**REITZ & JENS, INC.**  
CONSULTING ENGINEERS

Re: Site Visit / Spillway Inspection – December 2, 2010

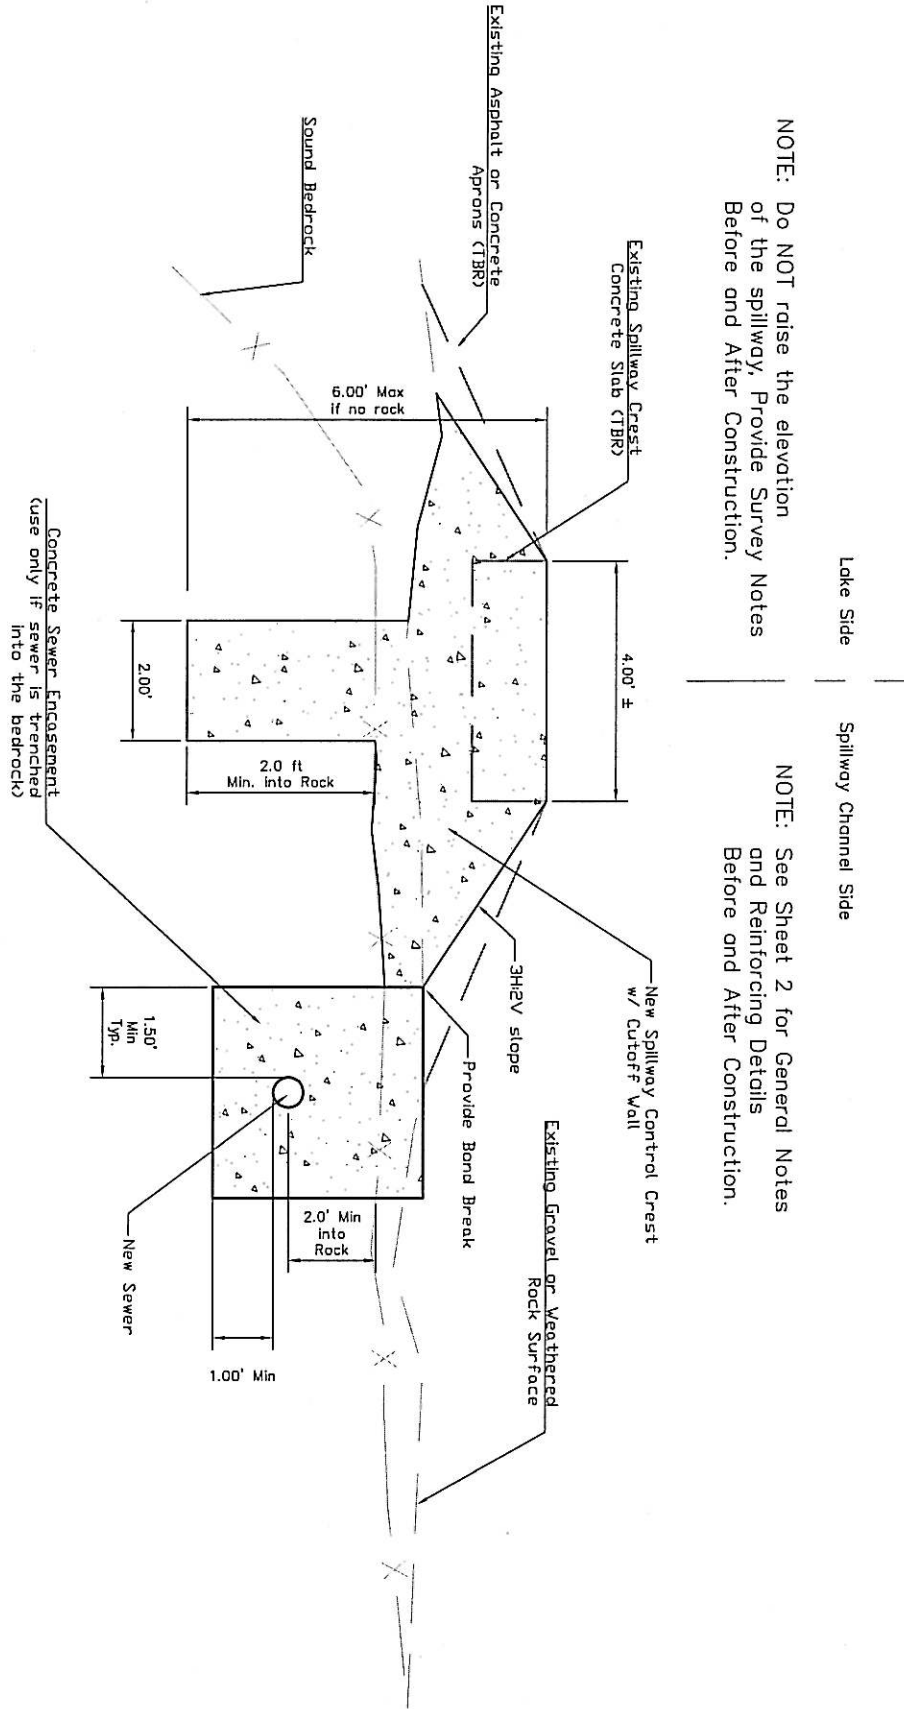
The photo on the right shows the existing spillway control crest. The crest has been undermined on the downstream side and there is evidence of seepage under the concrete crest slab. The protective apron on the downstream side has been washed out, probably over the location of the unknown backfill used to plug the trench cut into the spillway in 1981 when the lake had to be lowered at the request of the State Dam Safety Engineer. The field measured effective length of the spillway is about 58 feet, the concrete slabs are about 4 feet wide and appear to be no more than 12 to 15 inches thick. There is no visible evidence of a cutoff wall below any part of the spillway control crest.

The undermining of the spillway crest and the lack of a cutoff wall below the crest apron should be improved by replacement of a new spillway crest with a minimum 6 foot deep cutoff wall. We have prepared a typical section of the recommended replacement; these plans are attached to this memo and were previously sent to the committee. The top width of the spillway is not fixed, it can be varied to suit the needs of the membership. The spillway **MUST** be rebuilt no higher than the elevation of the present spillway, in order to avoid obtaining a permit from the MO Dam and Reservoir Safety Council. Replacement of the deteriorated spillway crest at the same elevation is considered routine maintenance and will not require a permit.

Section thru Spillway & ForceMain

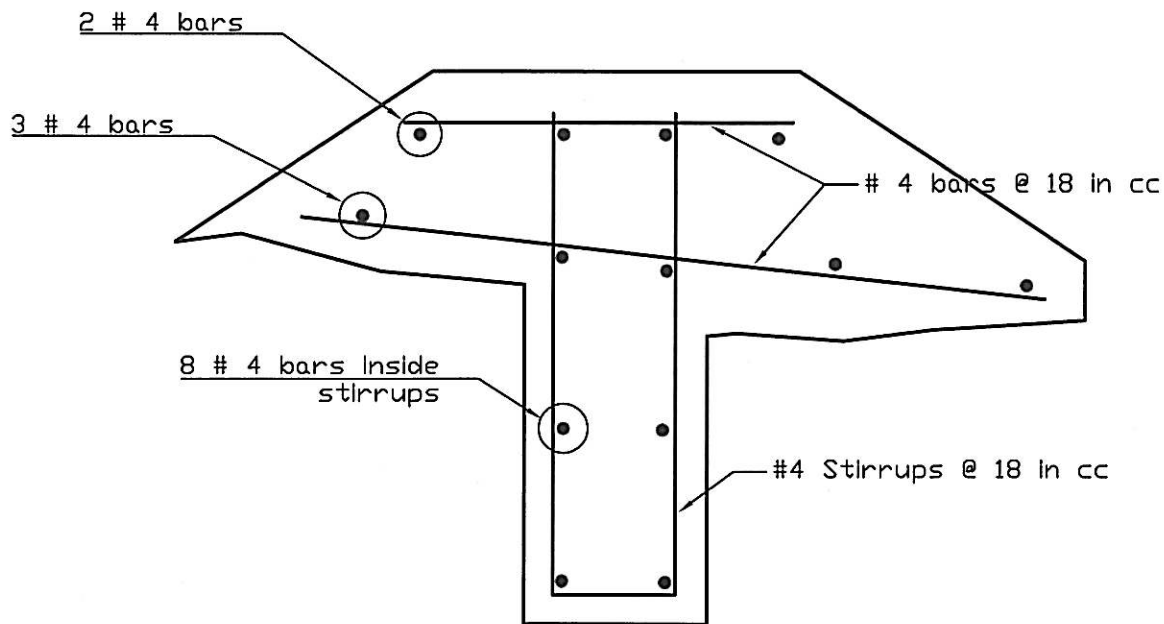
Discussion with the sewer contractor indicated that the sewer is planned to cross the spillway area downstream of the spillway control crest. We have included a suggested method of crossing through the rock if the contractor intends to trench the sewer across the spillway. If he intends to tunnel or bore the sewer across the spillway then the carrier pipe should be grouted into the rock. It is our opinion that either method of installing the sewer below the present spillway channel grades will not require a permit from Missouri Dam Safety.

We strongly recommend that any sewer crossing of the dam alignment be at an elevation above the permanent pool elevation, to avoid the probability of creating a seepage path through the dam.

NOTE: Do NOT raise the elevation of the spillway, Provide Survey Notes Before and After Construction.

If concrete sewer encasement is used, it should be a minimum of 5 feet from the spillway cutoff trench.

Lake Tishomingo  
Approx Weir Geometry

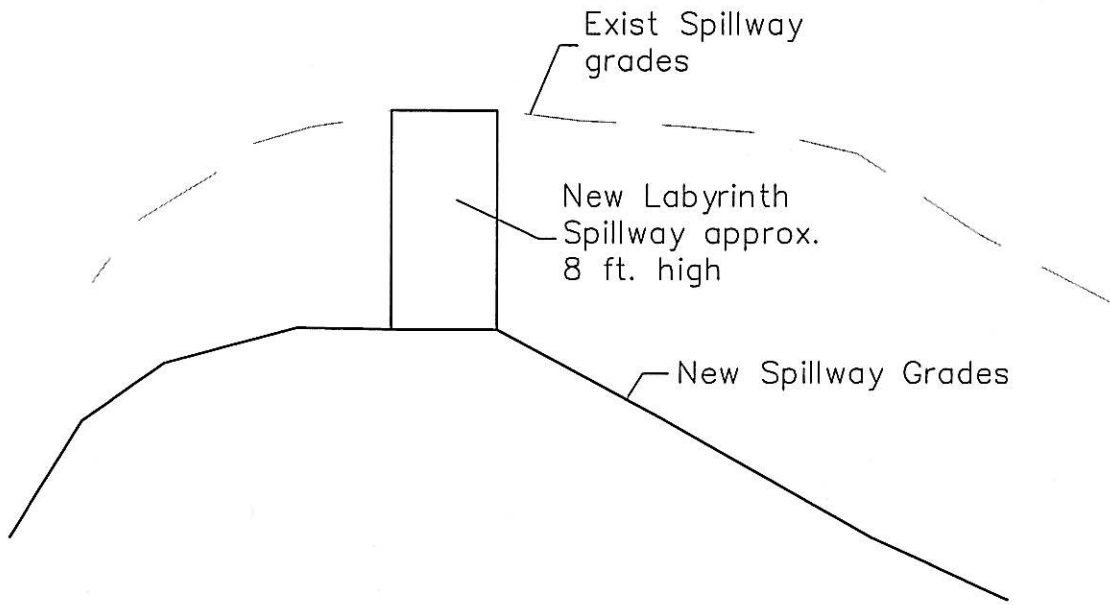
A detail sheet of a labyrinth spillway is shown on the next page, this sheet was handed out at the meeting. This spillway type is a way to effectively lengthen a narrow spillway without significantly widening the actual spillway location, however to make these work the spillway channel will have to be deepened, preliminary computations show that the deepening may be as much as 8 feet. The planned presence of the sewer crossing may affect the constructability of this labyrinth option.
